Access Compliance Report

Public Rights-of-Way

(Pedestrian Signals)

Intersection ID: N/A	Main Street:	Cross Street: N/A	Location: N/A
ADA ID: 0F1E9B891A01	Signal Type: One Push Button-APS	Overall Compliance: No	Severity Score: BTN 1: N/A BTN 2: N/A No BTN: N/A
Codes/Mitigation Info/Possible Solution		Field Measurements/Component Compliance

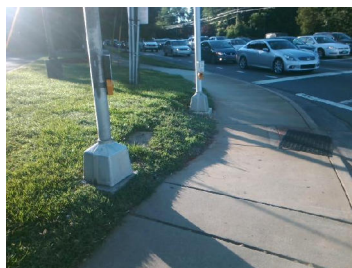
Surveyor Notes: TEXT HT 3/8

PROW/ADA: R410.6, TMUTCD 4e.08, R404.2, R404.3, R406.2, R209.1, MUTCD 4e.10

Yes	B 1 Clear Xing Direction?	ClearlyMarked	N/A	B 2 Clear Xing Direction?	N/A
	B 1 Crossing Direction	To W		B 2 Crossing Direction	N/A
Yes	B 1 DistanceTo XWalk (in)	0.0	N/A	B 2 DistanceTo XWalk (in)	N/A
No	B 1 DistanceTo Curb (in)	88.0	N/A	B 2 DistanceTo Curb (in)	N/A
Yes	B 1 Diameter (in)	2.0	N/A	B 2 Diameter (in)	N/A

Possible Solutions: Replace Signal Push Button With APS Button on New Post. Remove & Replace Sign.
